4.3 Key Uncertainties for the Value of the Lower Snake River Dams

Figure 19. BPA-Modeled LSR Dam Output During the 2001 Low Hydro Year with CRSO EIS Preferred Alternative operations

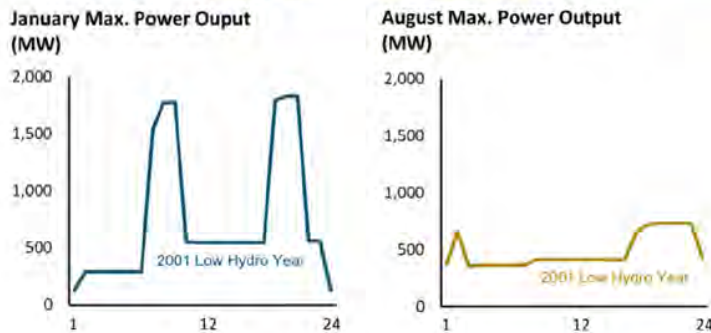
Comment [AB30]: Eve/BPA to review and confirm

Comment [EAJ31]: Might be worth adding if someone looks at chart without reading the detail in the text
